I think this paper is suitable for publication, but the authors should address the following concerns first:

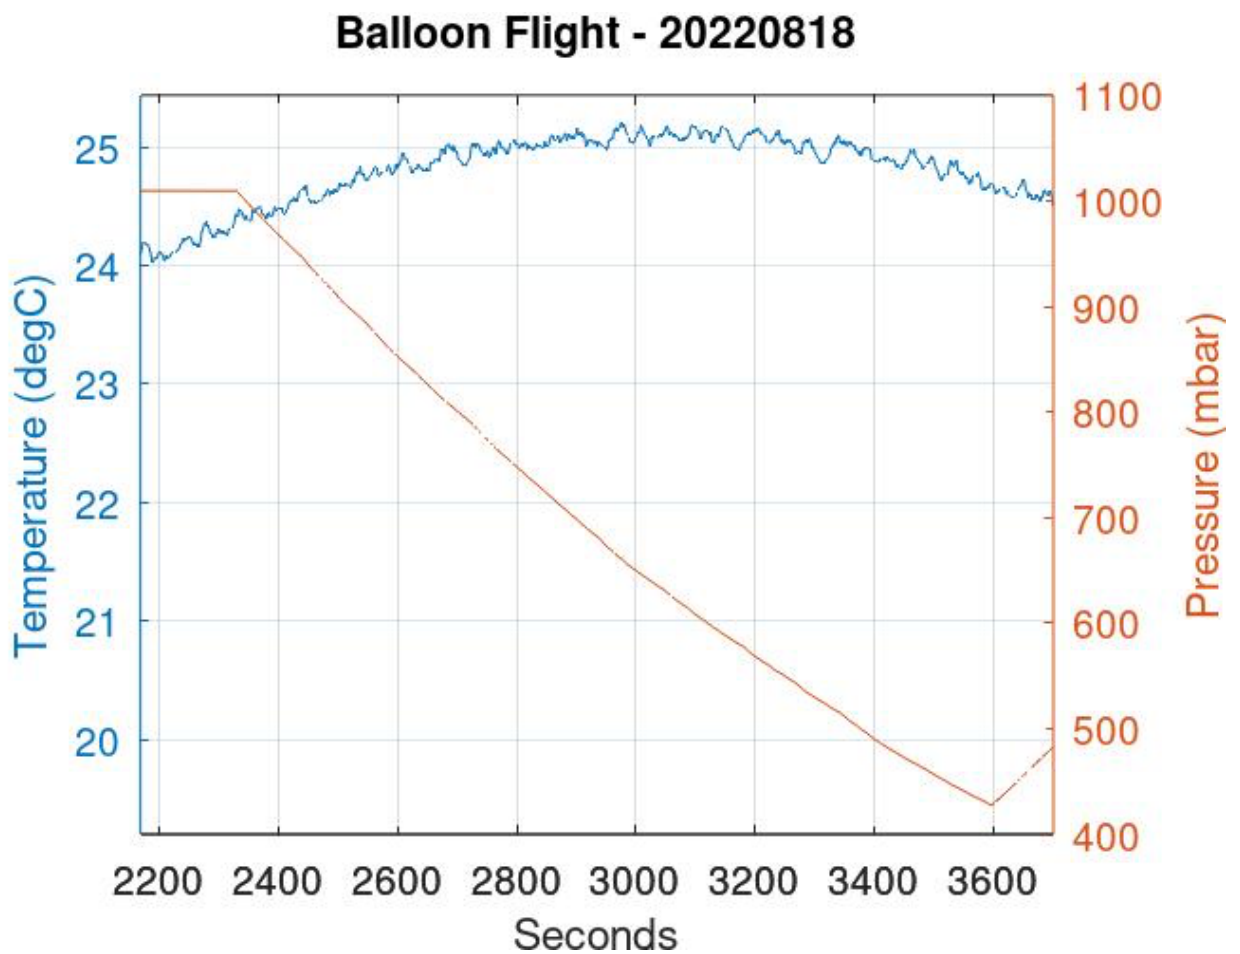
- 1) Comment from reviewer #2: *LED spectrum stability: LED emission spectrum can be very sensitive to its temperature and as you described, the LED here is temperature controlled at 25 degrees. Can you show that this is also the case at high altitudes with environment temperatures well below zero? presumably, that would make life easier for the TEC unless the LED is not generating enough heat.*

Response: Thank you for your comment. Our instrument was designed to fly on a drone up to 400 feet or on a balloon in the boundary layer. Given flight data shown in Figure 7 goes to 7km before balloon cutdown, our temperature in the instrument enclosure (which is insulated) deviated less than 1 deg C between launch (at ~2350 seconds) and cutdown (at ~3600 seconds) as seen in the plot below. I added a sentence to the current paper (line 249) indicating this temperature deviation.
